Public Works Department – Engineering Division

ADDENDUM NO. 4

PROJECT 5067 WTP FILTER IMPROVEMENTS AND HYPOCHLORITE CONVERSION

DWG. NO.
S643

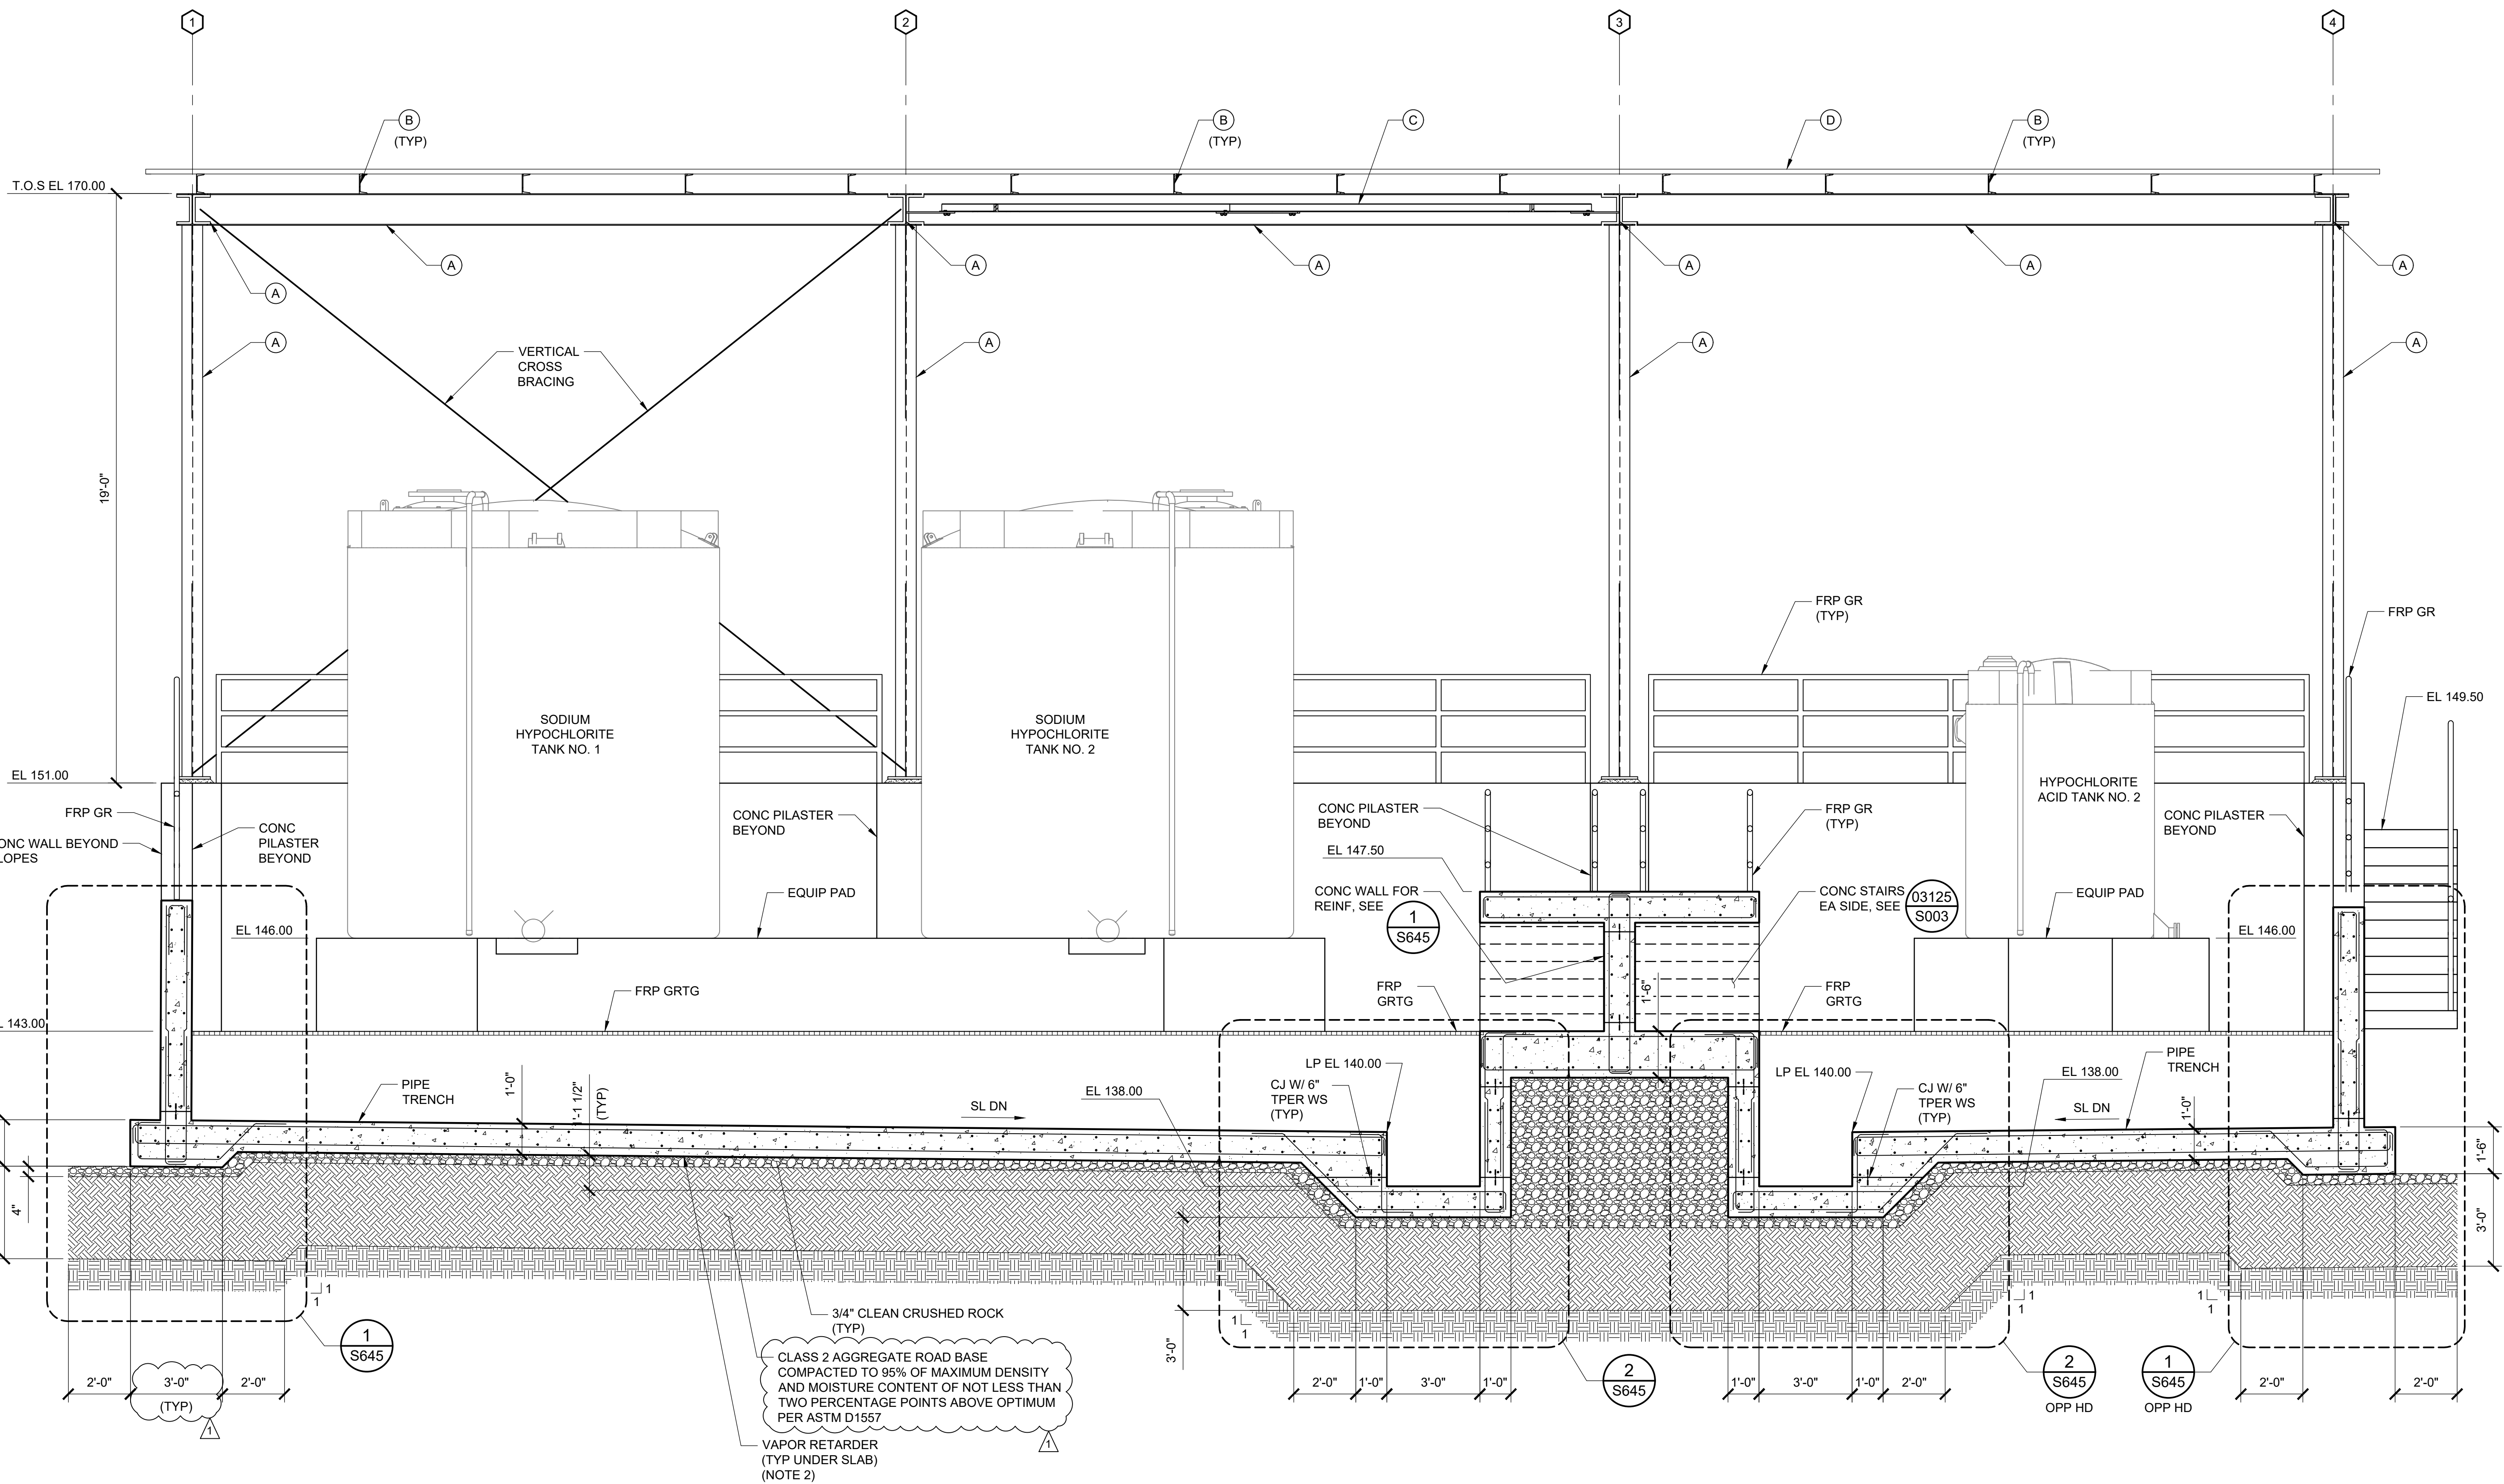
24. Replace Drawing S302 with the attached updated drawing S302.
25. Replace Drawing S310 with the attached updated drawing S310.
26. Replace Drawing S643 with the attached updated drawing S643.

SECTION B
SCALE: 3/8"=1'-0" S641, S642

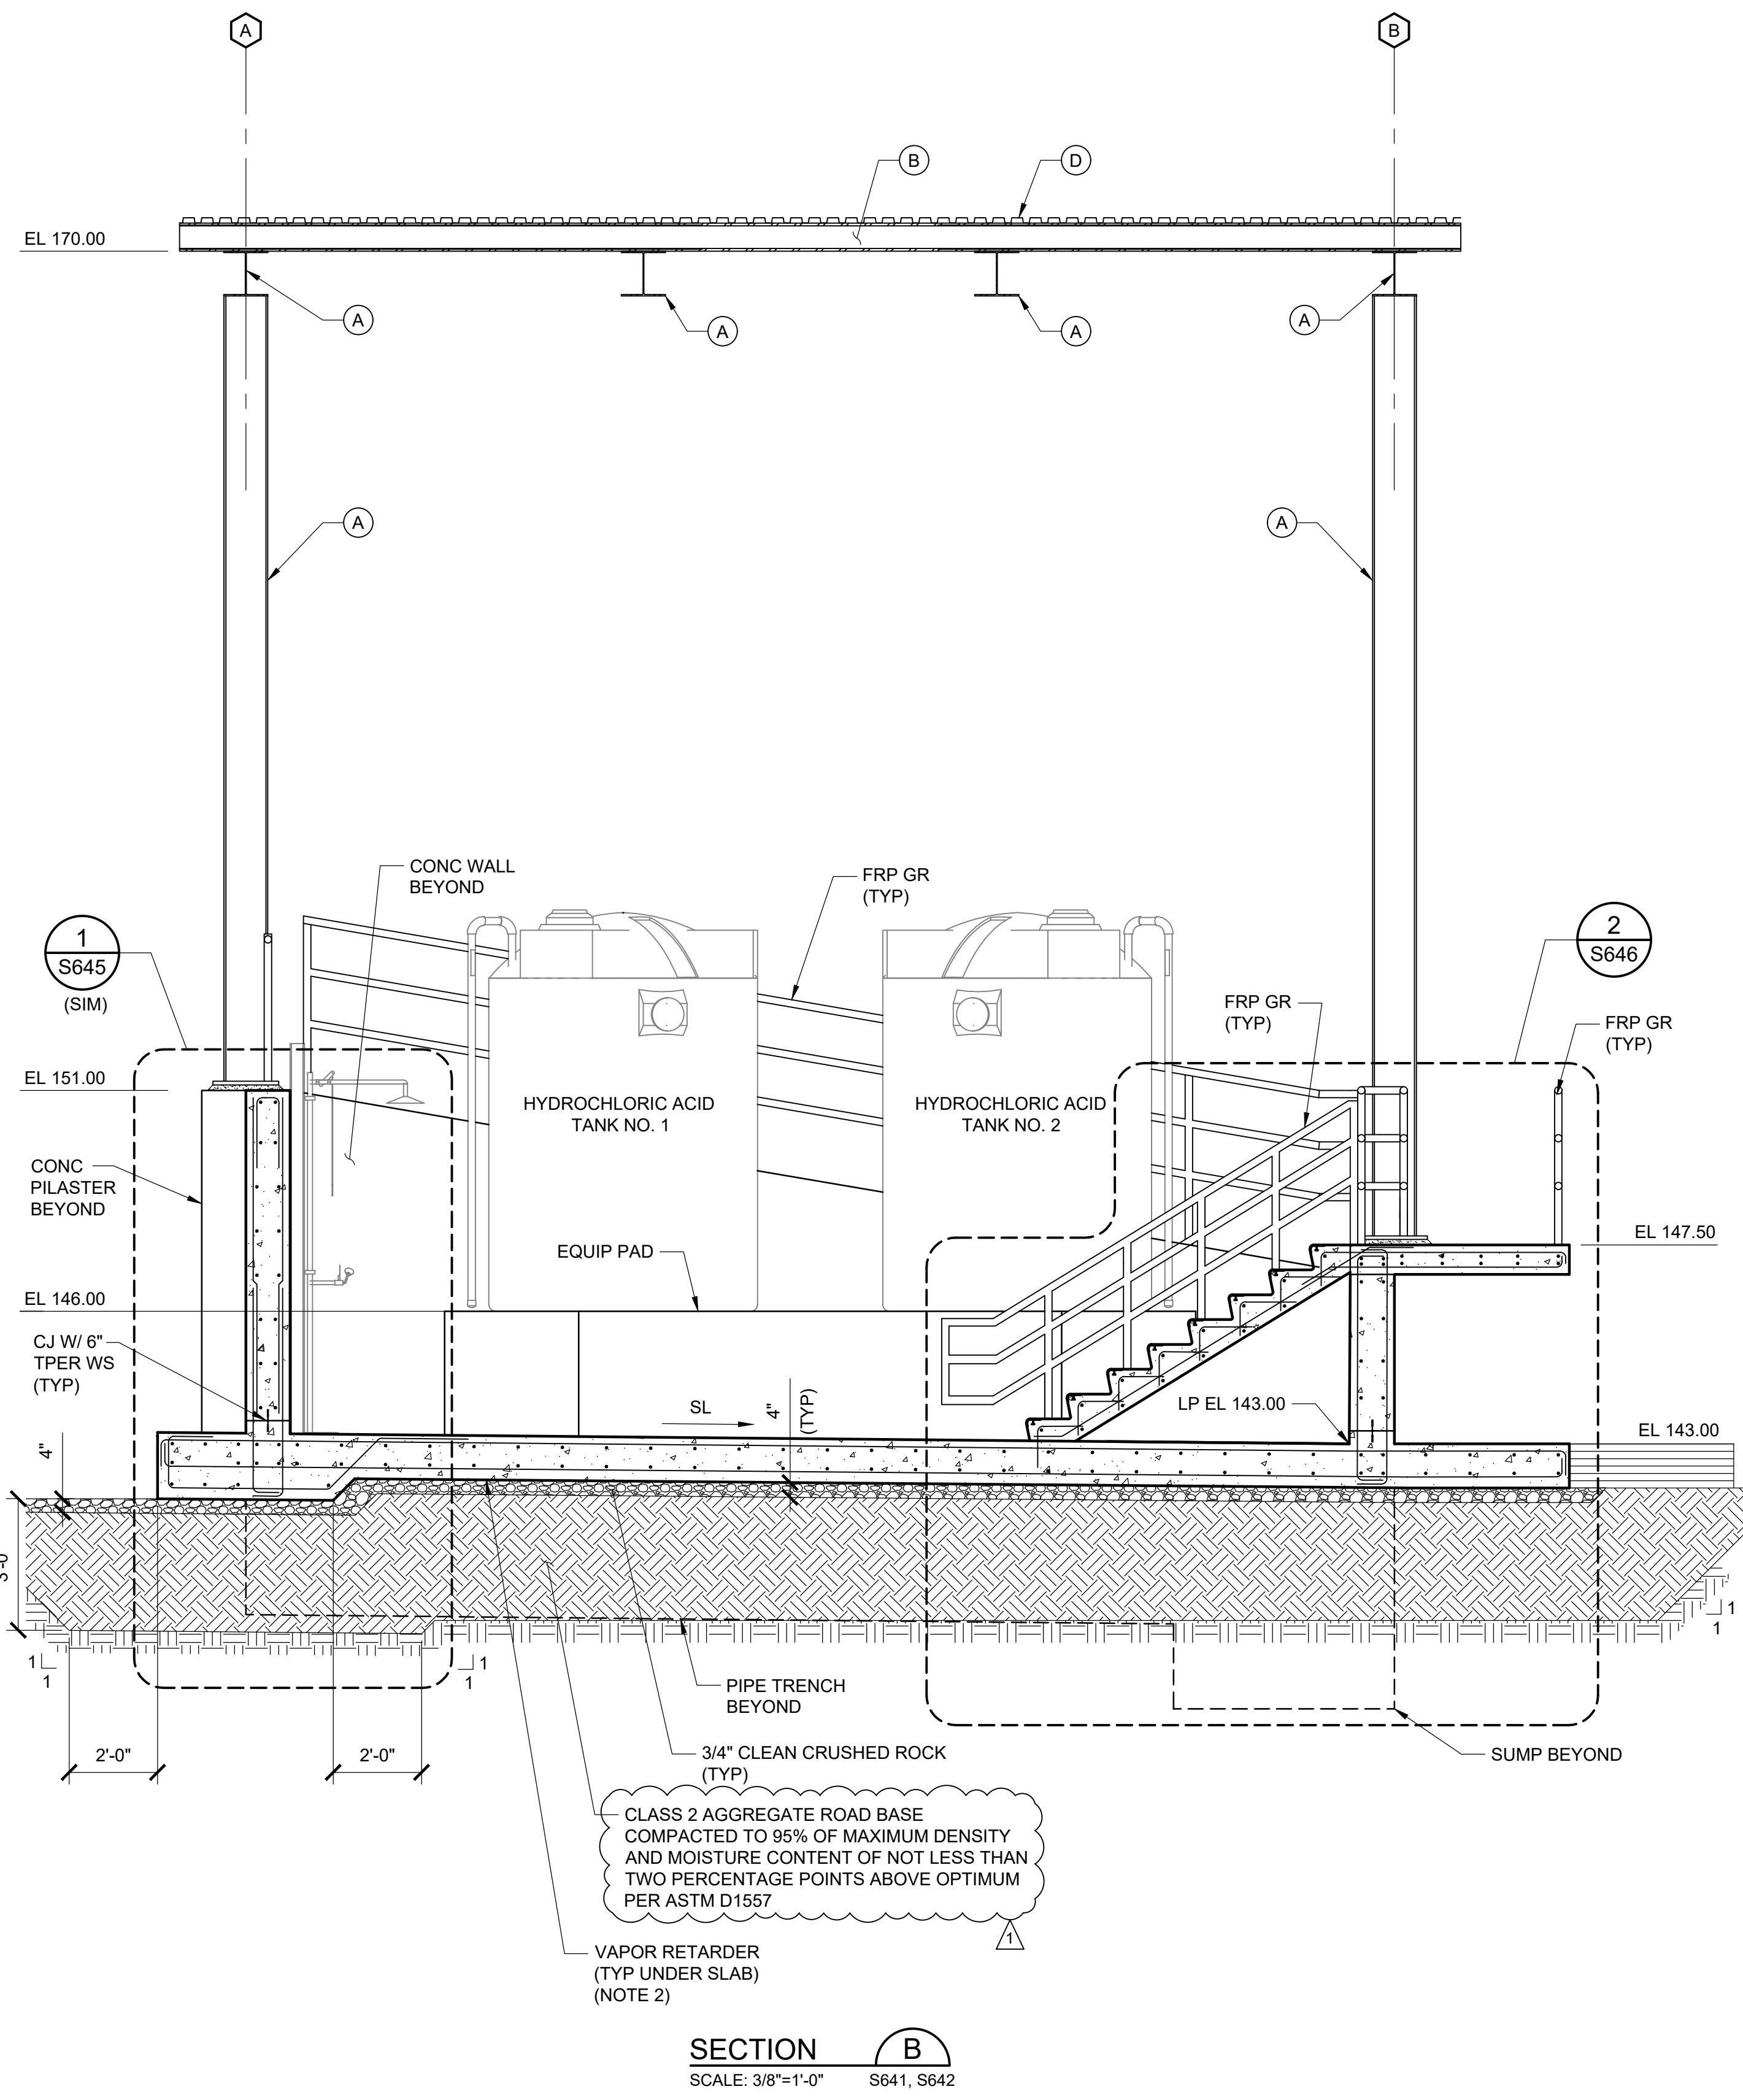
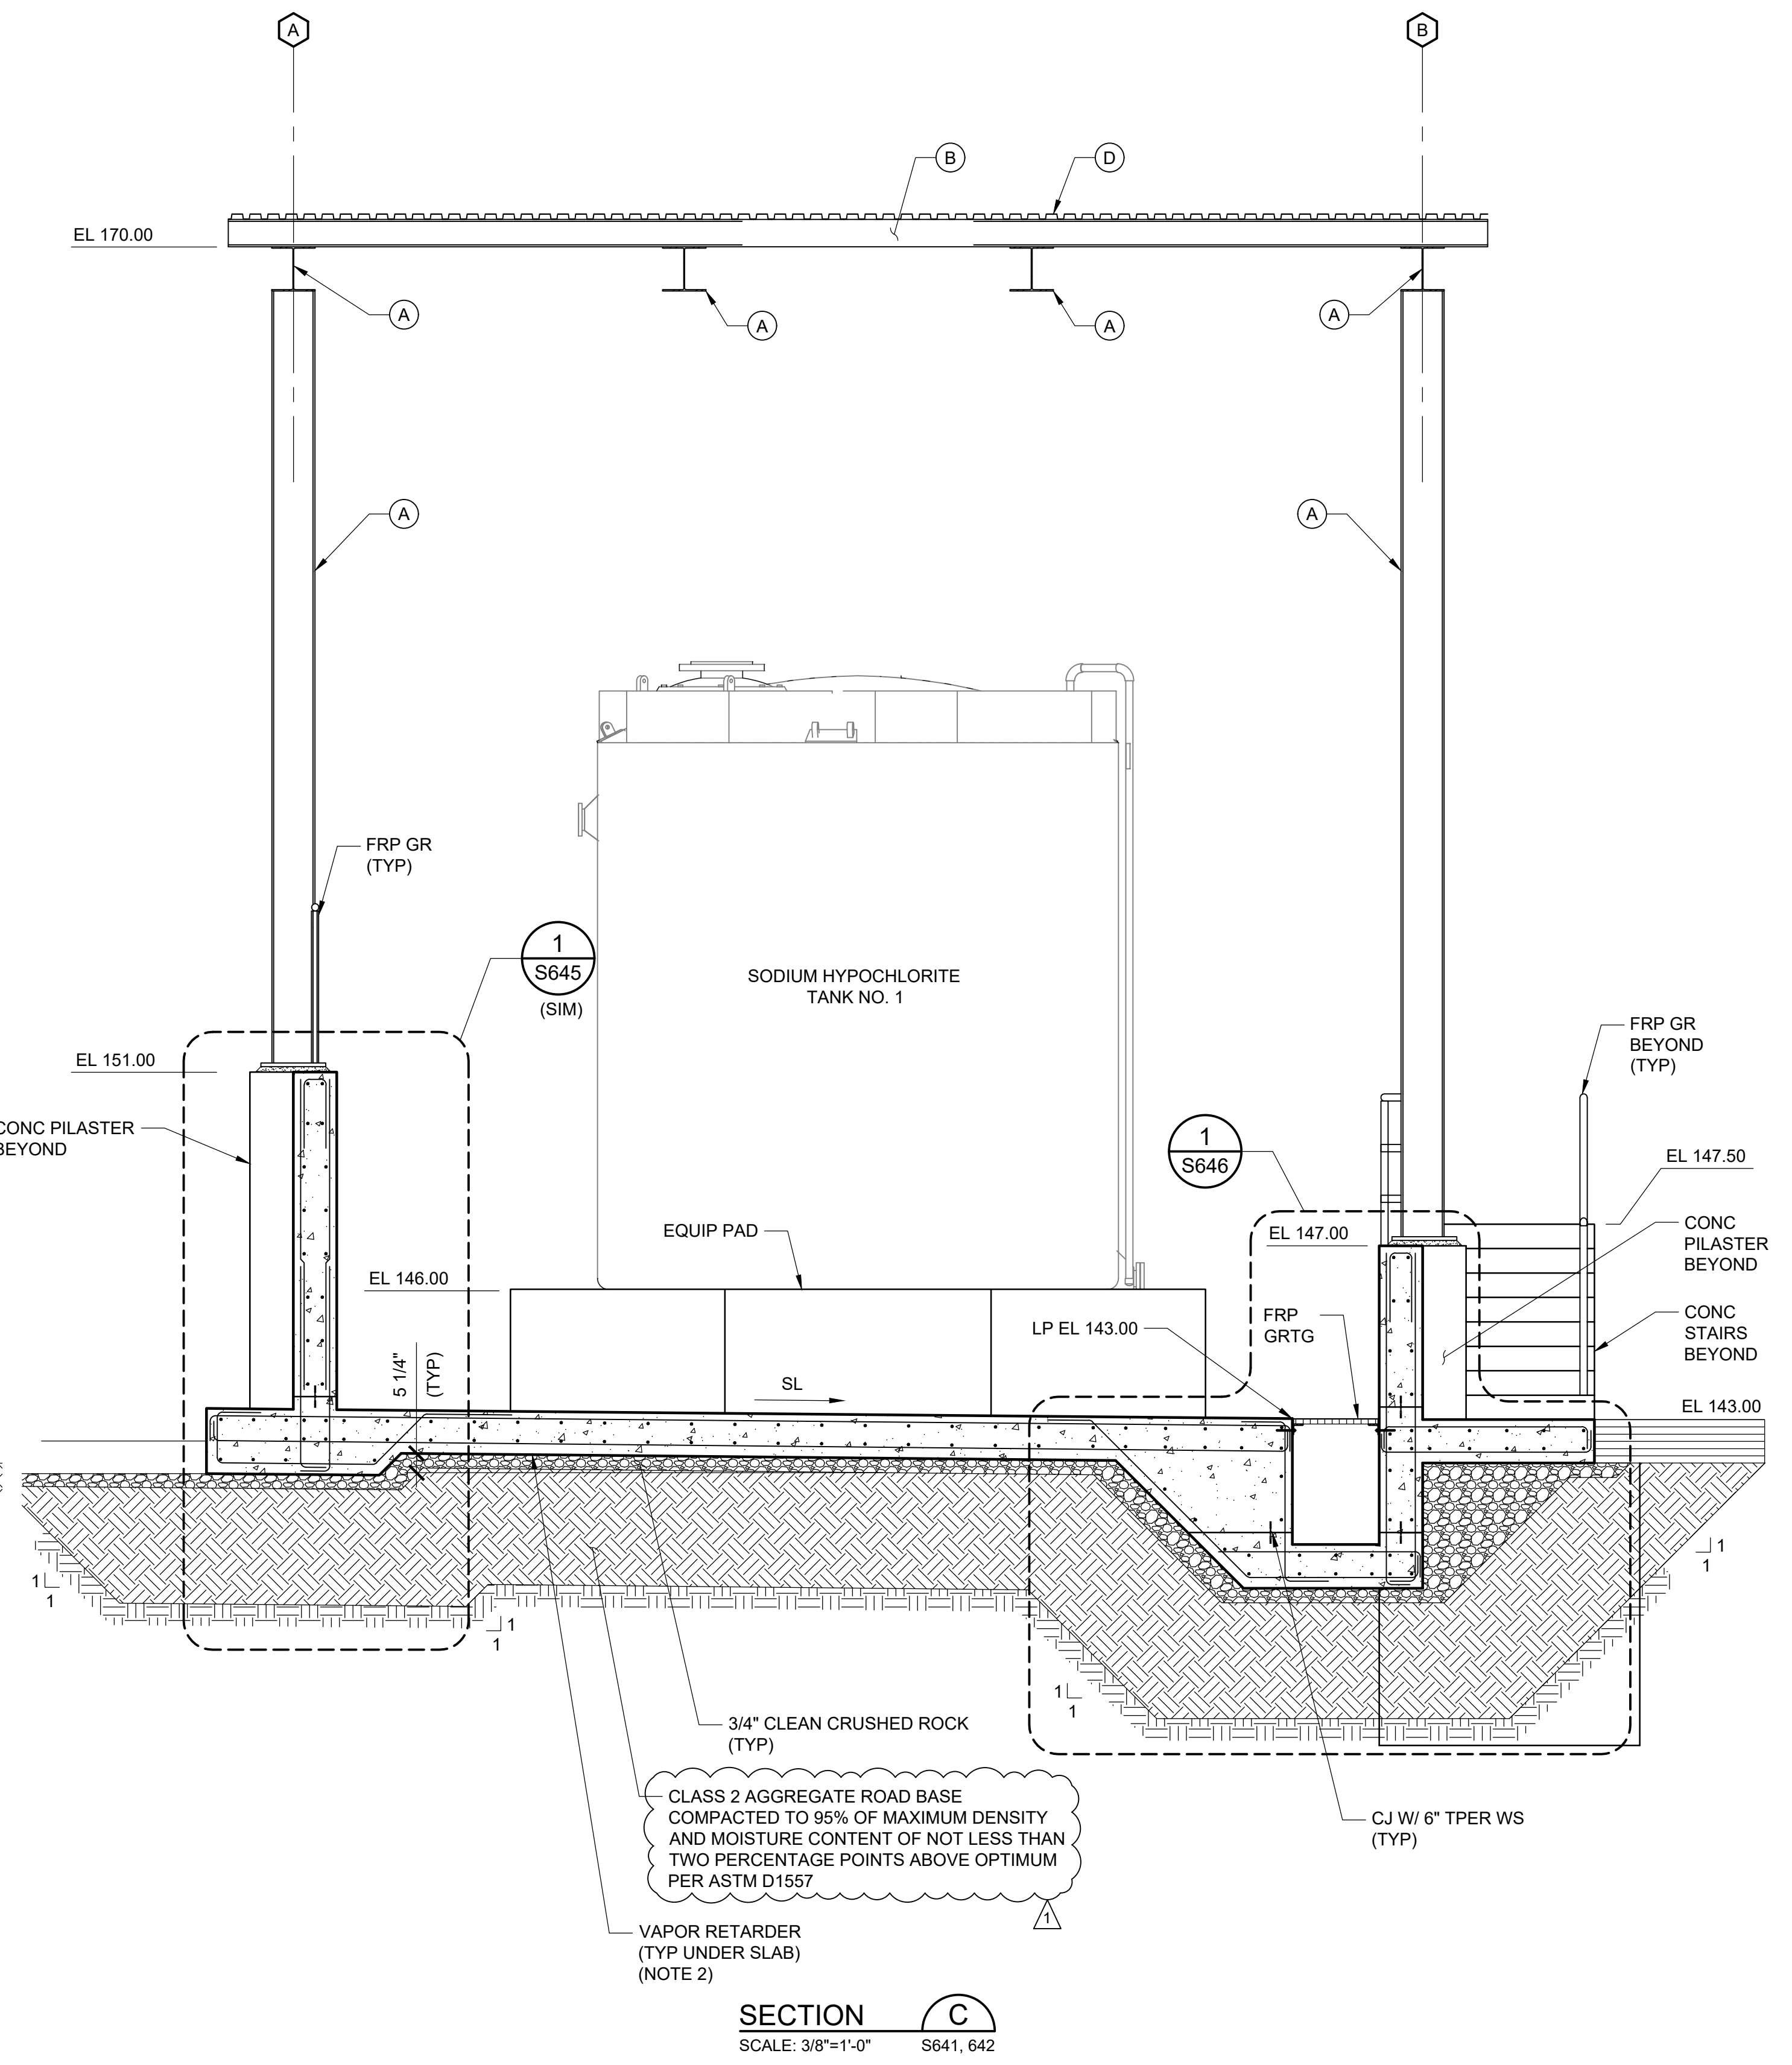
27. Replace Drawing S644 with the attached updated drawing S644.
28. Add specification 07 72 33 Aluminum Access Hatches.
29. Replace the Conduit Schedule in Specification 26 05 33, Appendix A, with the updated Conduit Schedule.
